HOWARD COUNTY HISTORIC PRESERVATION COMMISSION
ELlicott City Historic District ■ LAWYERS HILL HISTORIC DISTRICT
3430 Court House Drive ■ Ellicott City, Maryland 21043
Administered by the Department of Planning and Zoning

June Minutes

Thursday, June 7, 2018; 7:00 p.m.

Figure 3 - Section new construction compared to historic building

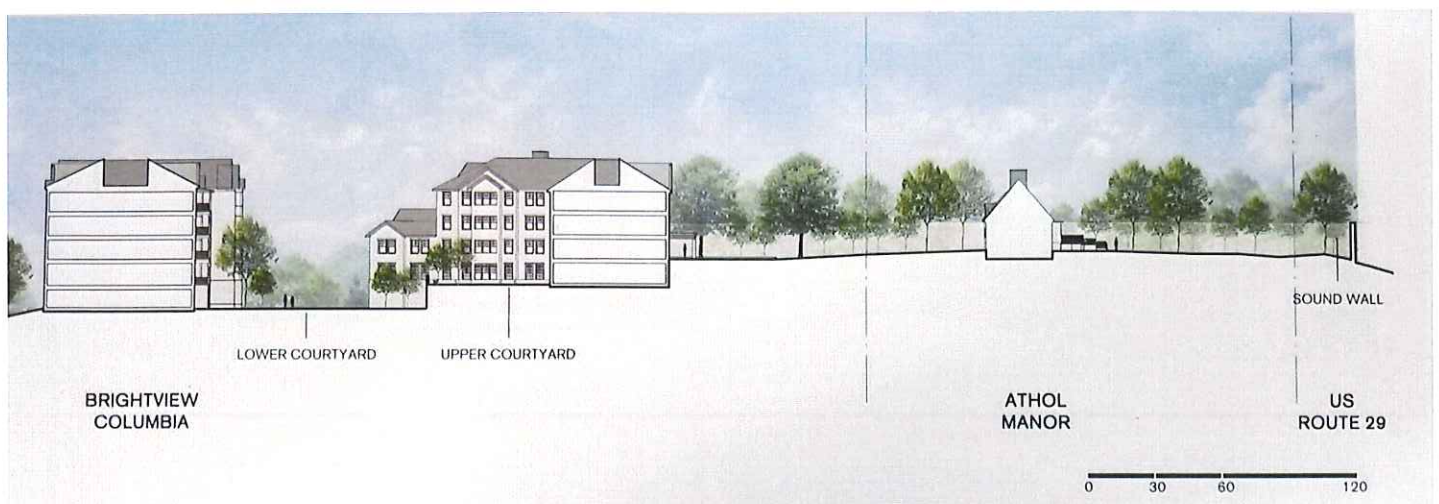
Staff Comments: Overall the design complies with Section 16.118 of the subdivision and land development regulations for the protection of historic resources. The section in Figure 3, shows how the new structure will relate to the historic structure. As explained in the application, the shortest side of the new building will face the historic structure. As a result, the new building will not overpower the historic building.

Figure 7 - Site map of project

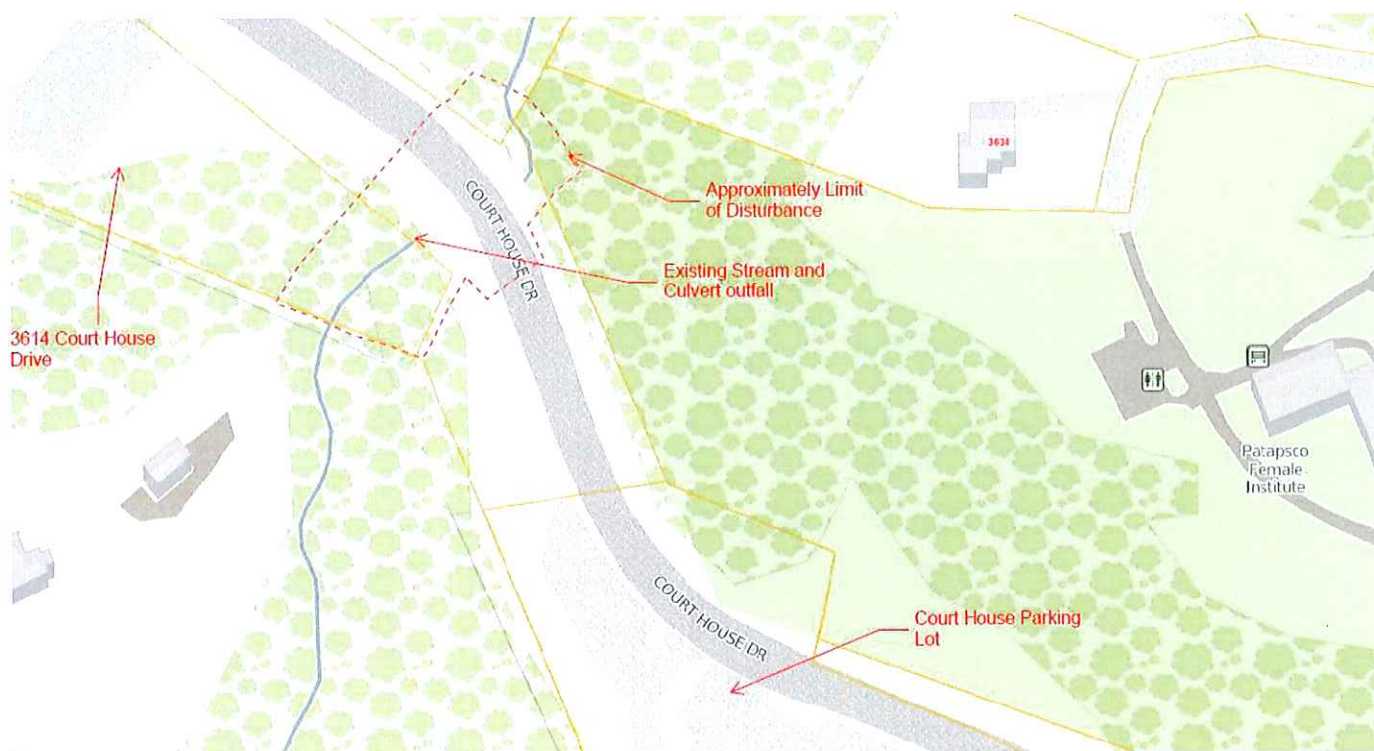
Figure 8 below shows the existing stone wall on the south side of Court House Drive, that is proposed to be buried. The date of the wall is unknown, but the Applicant believes it may date to the construction of the road. Staff finds the wall is a historic wall that most likely dates to an earlier, lower road bed, as it would be unusual for the current road to have been constructed with stone instead of concrete. Figure 9 is an example of what the side with the stone wall will look like after it is buried.

Staff inquired if a structural analysis of the wall was done and the consultant replied, "We did not do any structural analysis of the wall. The degree of damage the wall has already sustained, and the variability of wall materials and their overall integrity would make it very difficult to accurately analyze the structure; doing so would likely require a test hole, which could further compromise the slope and wall stability and roadway safety. We also needed to lessen the steepness of the roadway embankment slope to make it stable and we could not do that with the existing wall."

Staff Comments: The application does not comply with the recommendations in the Ellicott City Historic District Design Guidelines. Chapter 9 explains, "Ellicott City's natural setting is essential to its character...Ellicott City's buildings and streets were fitted into the steep hillsides without major changes to the natural land forms. Retaining walls or the outer walls of buildings have been used to terrace the land to create the narrow, level areas needed for buildings, roads, gardens and other improvements." Chapter 9 recommends, "retain landscaping patterns that reflect the historic development of the property" and "preserve historic features, such as retaining walls, freestanding walls, fences...and steps. When possible, reuse the historic building material to repair or restore these structures." The stone wall is most likely a historic landscaping element and the burial of the wall would not comply with the Guidelines.

Staff Recommendation: Staff recommends an alternate scheme for the stabilization of the slope be considered rather than burying the wall. Staff recommends approval of the concrete curbing and the removal of trees that are growing into the stone wall and slope between the wall and Court House Drive, which includes trees 30 and 31.

Figure 14 - Site plan showing proposed addition

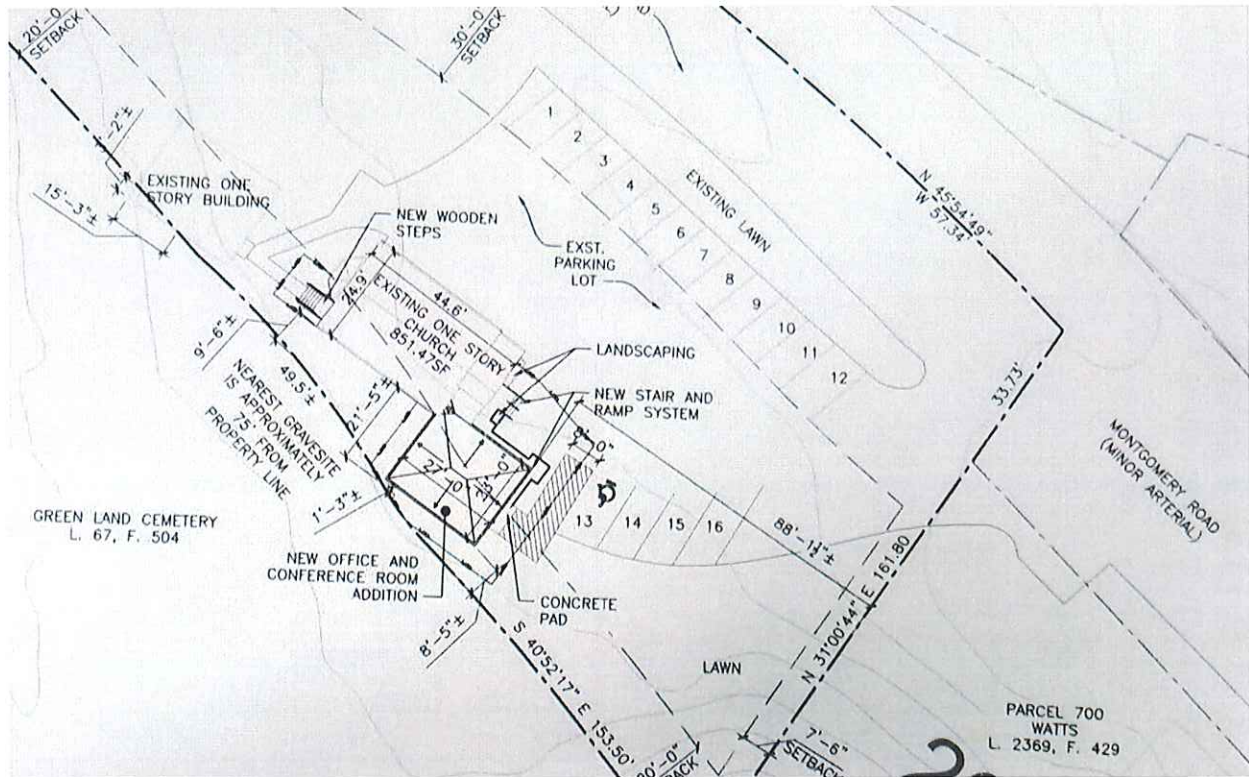
Staff Comments: Additions to historic structure should be attached to the rear of buildings. This addition will be located on the front corner and will be highly visible. The location of the addition on the front of the building does not comply with the Secretary of the Interior Standards for Rehabilitation, Standards #2 and #9.

The front of a historic building is the most character defining part of a building and the spatial relationship of the church to its surroundings will be comprised by the placement of the addition. If possible, the addition should be moved to the rear of the building, where the front façade and form of the church and steeple will remain intact.

- 1) The addition be moved to the rear of the property
- 2) The windows in the addition be one consistent type using the arched window, to be compatible with the historic church.

Figure 16 - Rear elevation

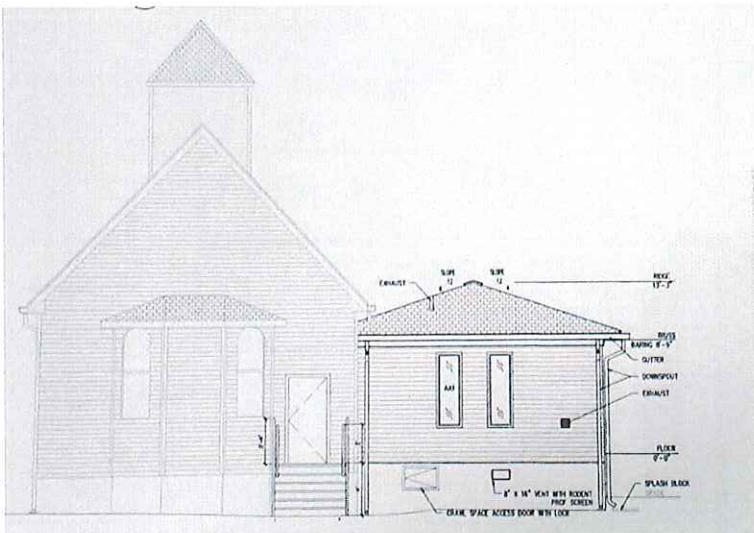
The less visible facades of the new building, the rear (northwest view – Figure 16) and side (northeast view – Figure 17) elevations both contain rectangular windows. From the rear view, the arched windows on the historic building are highly visible next to the proposed rectangular windows. The addition is not a large building and it would be more consistent and historically appropriate for all of the new windows to be the simple arched window, rather than mixing types.

Figure 18 - Proposed synthetic product

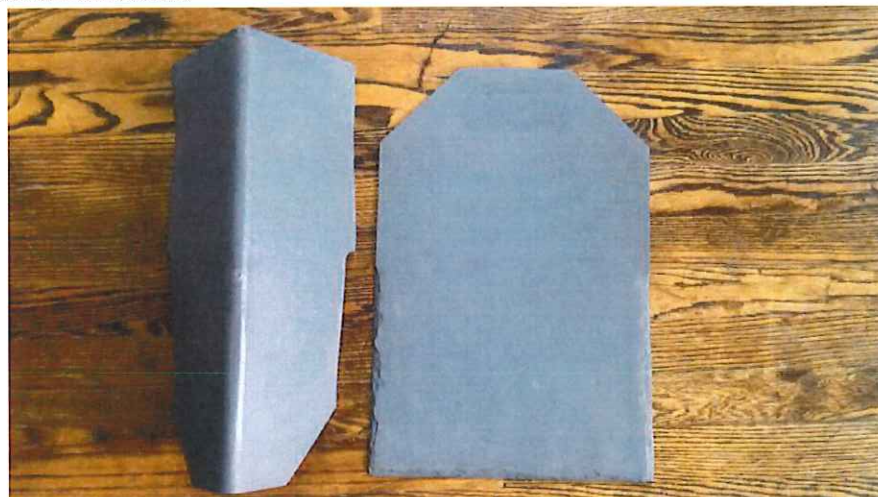
If a complete replacement of the slate roof is determined to be necessary, the replacement should be in-kind, with slate. The replacement with a synthetic product does not comply with the Standards for

The proposed synthetic slate shingles are constructed of recycled rubber and plastic. While there may be some variation in color due to the manufacturing process, there is not the level and polychromatic variation that is inherent with actual slate. The color on synthetic slates is dull and matte, whereas slate has more of a natural sheen because it is a metamorphic rock comprised of shale or mudstone that contains minerals such as quartz, feldspar, calcite, pyrite and hematite. A rubber and plastic product cannot replicate the aesthetic and visual qualities of natural slate. Slate tends to be thin but is very durable, whereas the synthetic version is much thicker and creates a bulkier, heavier appearance on the historic structure. The proportion, texture and quality of the natural product is not accurately replicated in the synthetic version, and therefore, they are not comparable products. Natural slate can be replaced with the same material, and the replacement can utilize the financial incentives that are available for proper in-kind replacement.

Staff Recommendation: Staff recommends Denial as submitted.
